OTAY RANCH VILLAGE SIX SECTIONAL PLANNING AREA (SPA) PLAN

**ADDENDUM
TO THE
FINAL ENVIRONMENTAL IMPACT REPORT
FOR THE
OTAY RANCH VILLAGE SIX SECTIONAL PLANNING AREA (SPA) PLAN
EIR-98-01
SCH #2001041033**

Otay Ranch Village Six Sectional Planning Area (SPA) Plan
Second Tier EIR 98-01
Letters of Comment and Responses

FIGURE 3-5
Conceptual Tentative Map
Village Six Otay Ranch
Development Plan

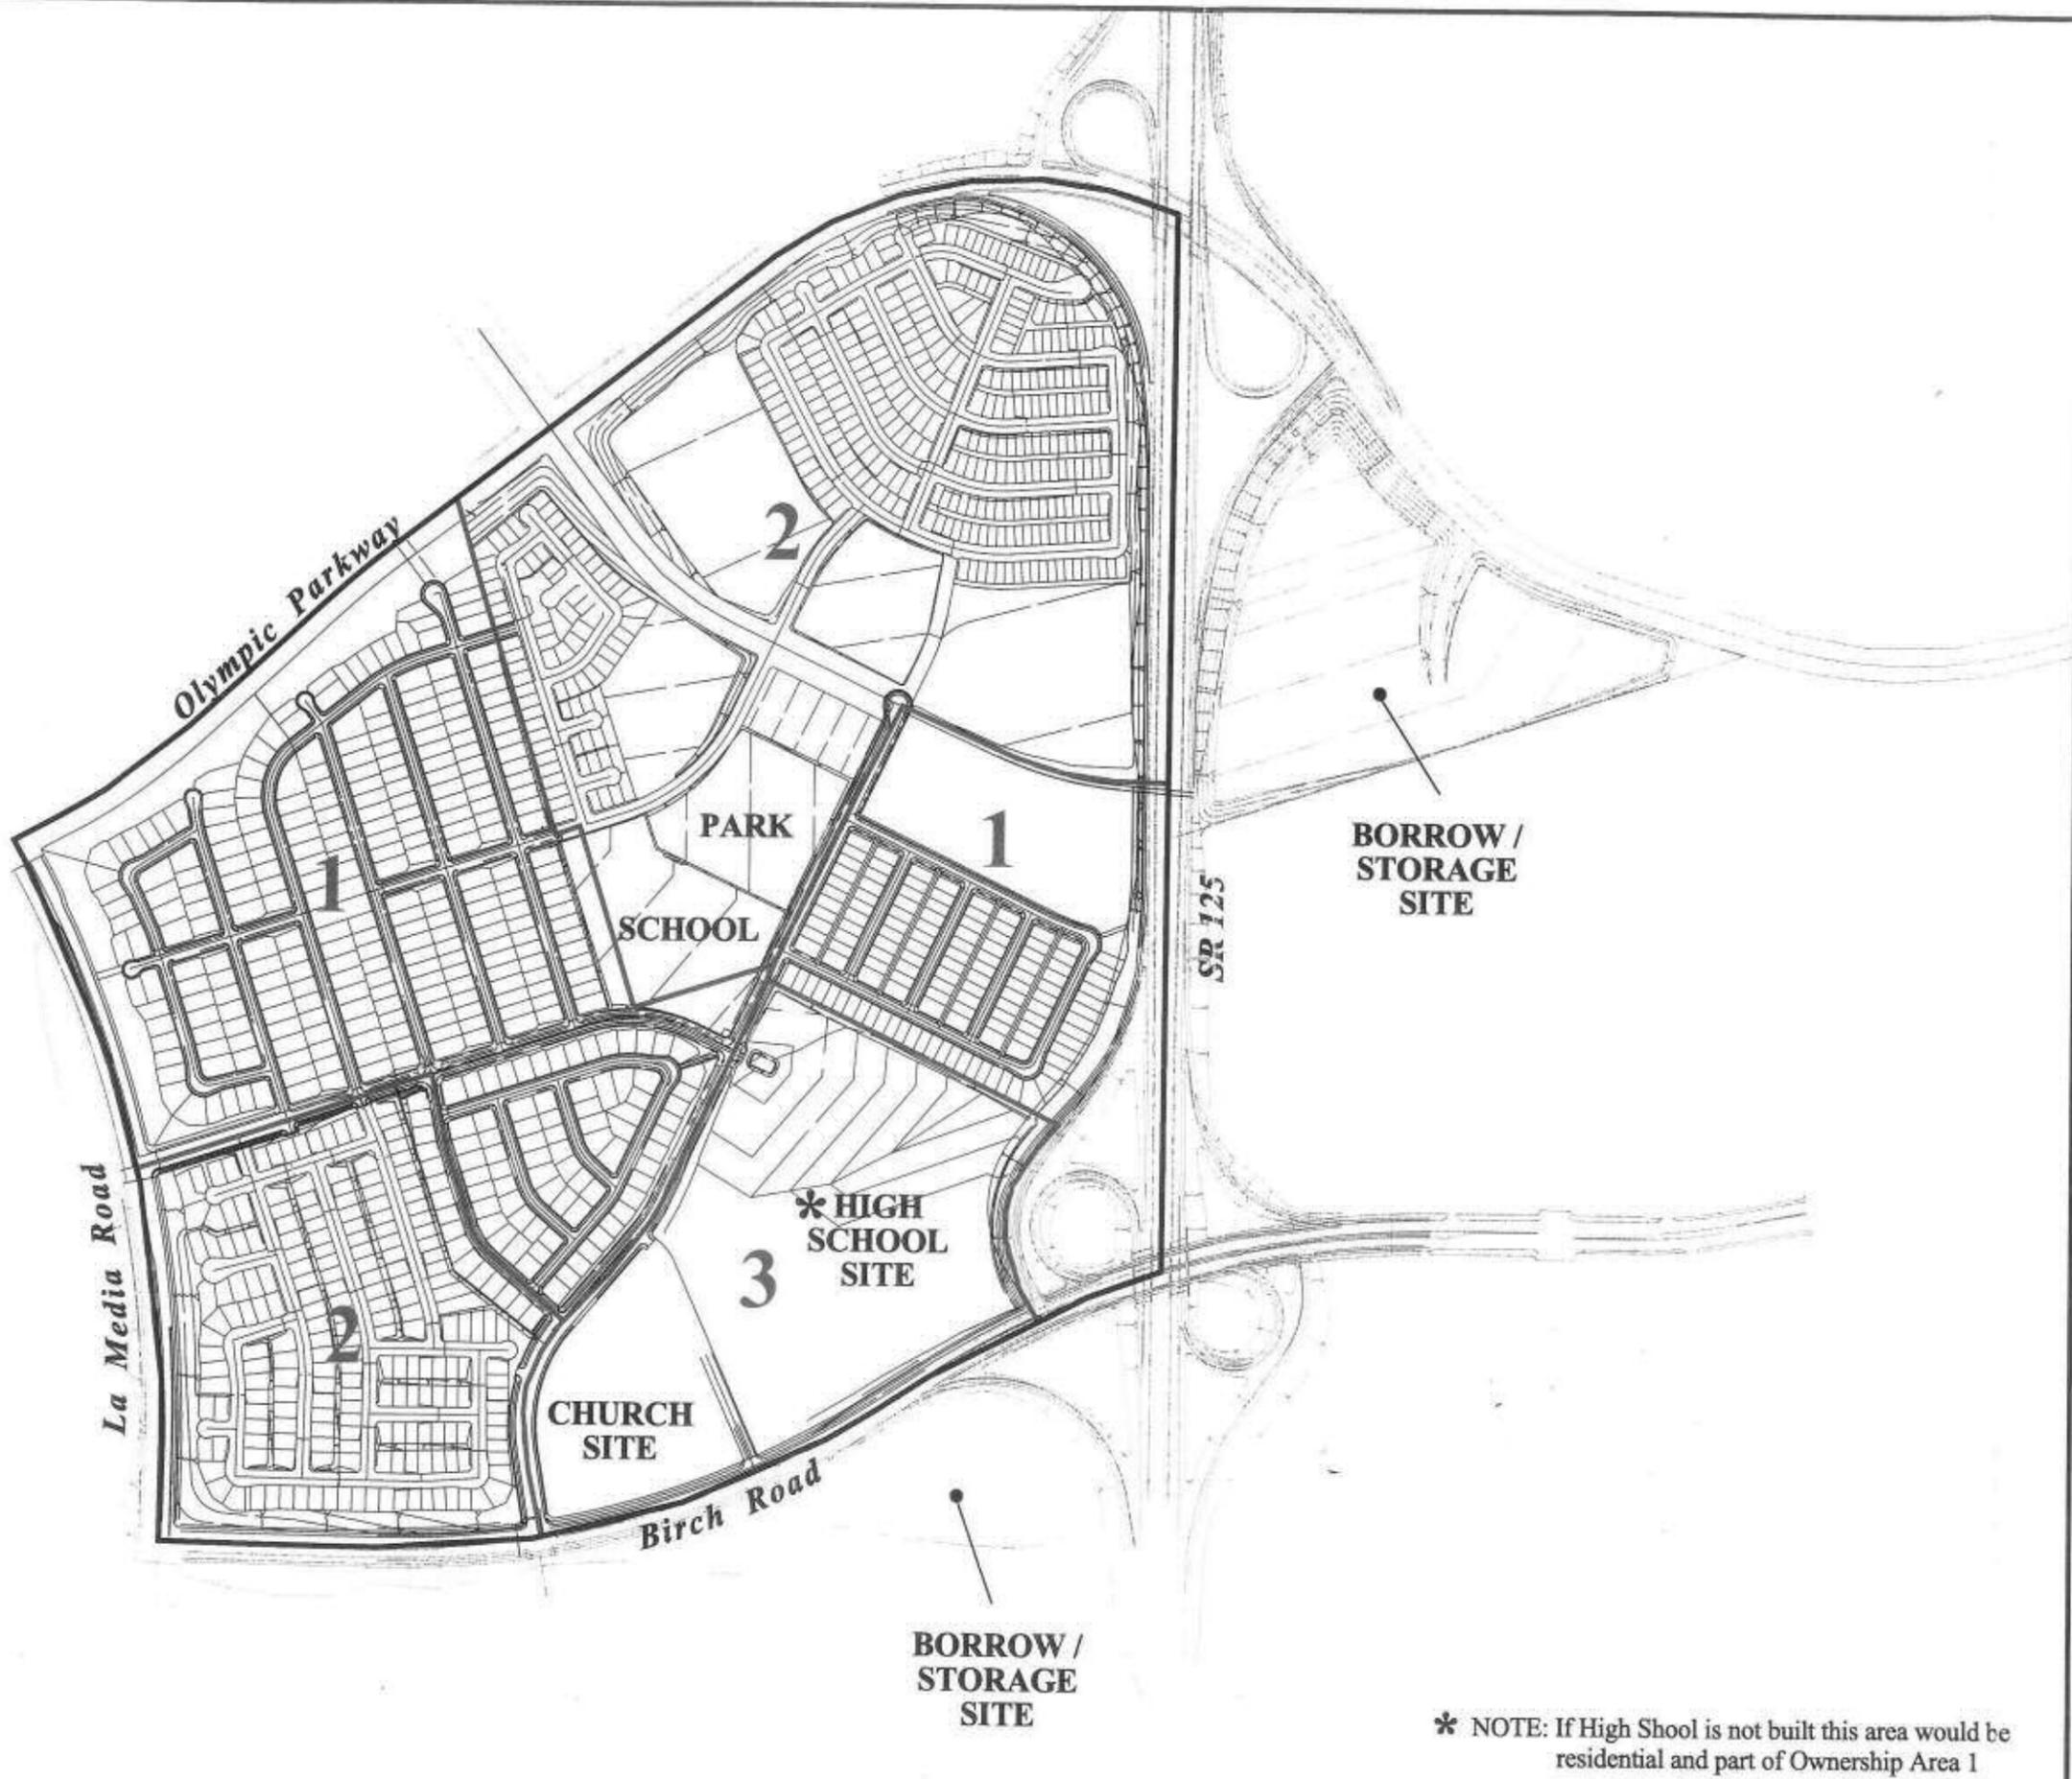
- D-13 • Figure 3-5 shows borrow/storage sites near the interchanges at Olympic Parkway and Birch Road. Please clarify whether these are within the future SR-125 right of way or not.

FIGURE 5.2-2
Landscape Concept
 Village Six Otay Ranch Development Plan

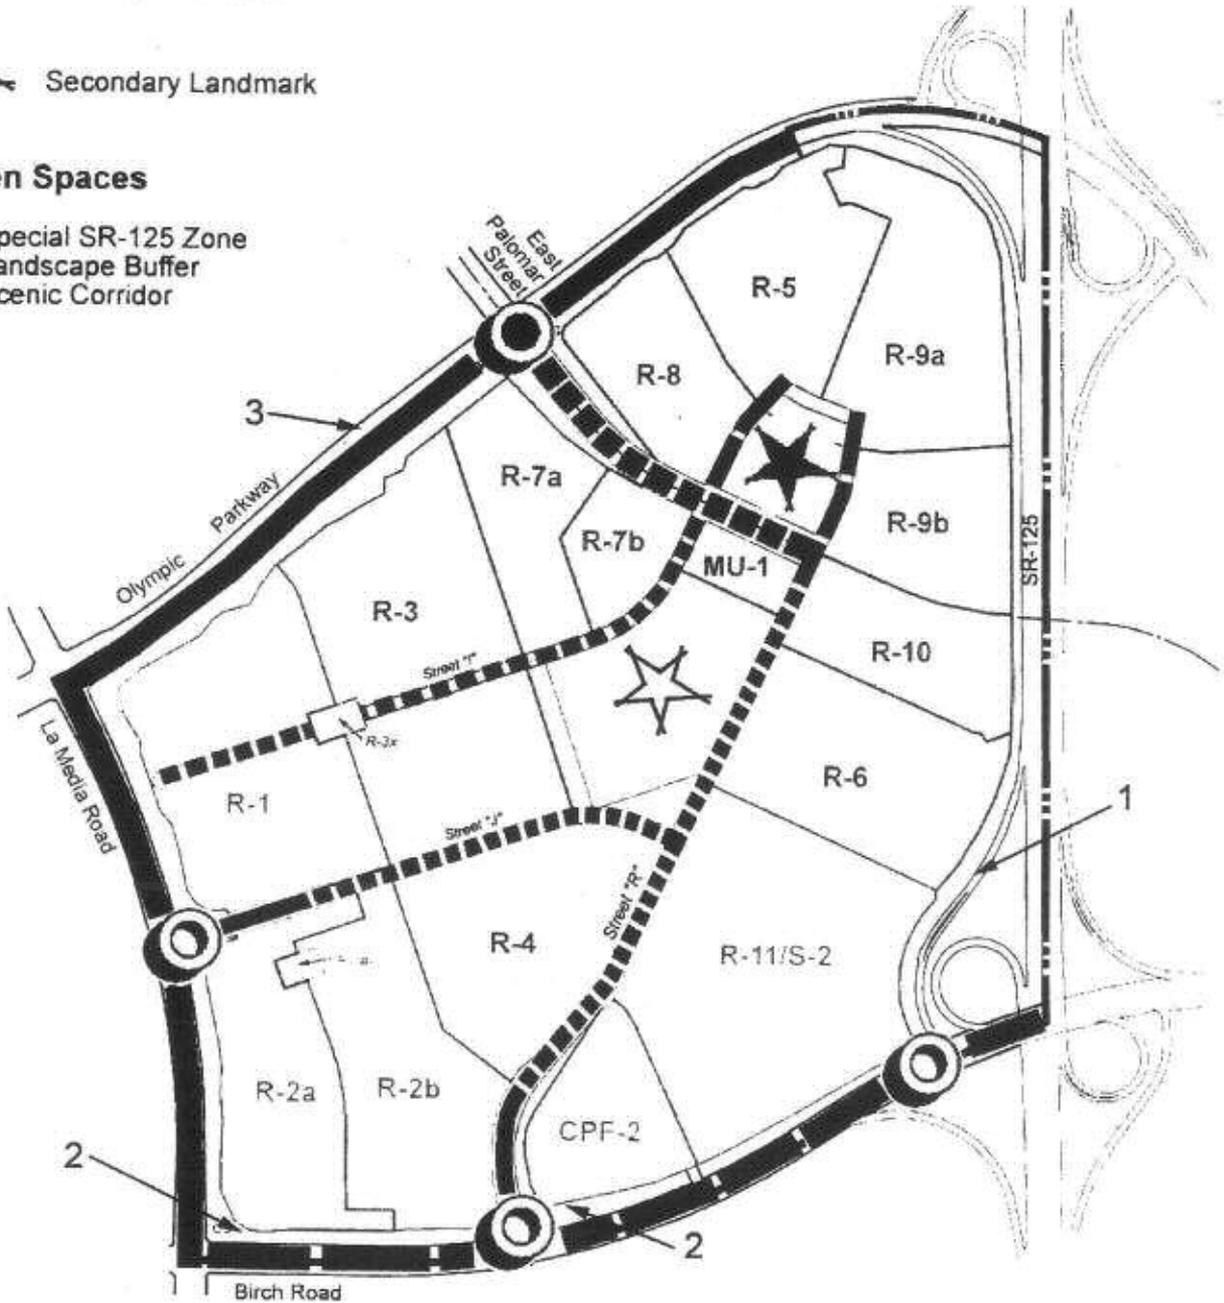
- D-14
- The DEIR identifies on Figure 5.2-2 a special SR-125 Landscape Zone, but the document does not discuss what this is. The City of Chula Vista needs to coordinate with Caltrans/CTV on this, given that this special zone is at the widened interchange with Birch Road.
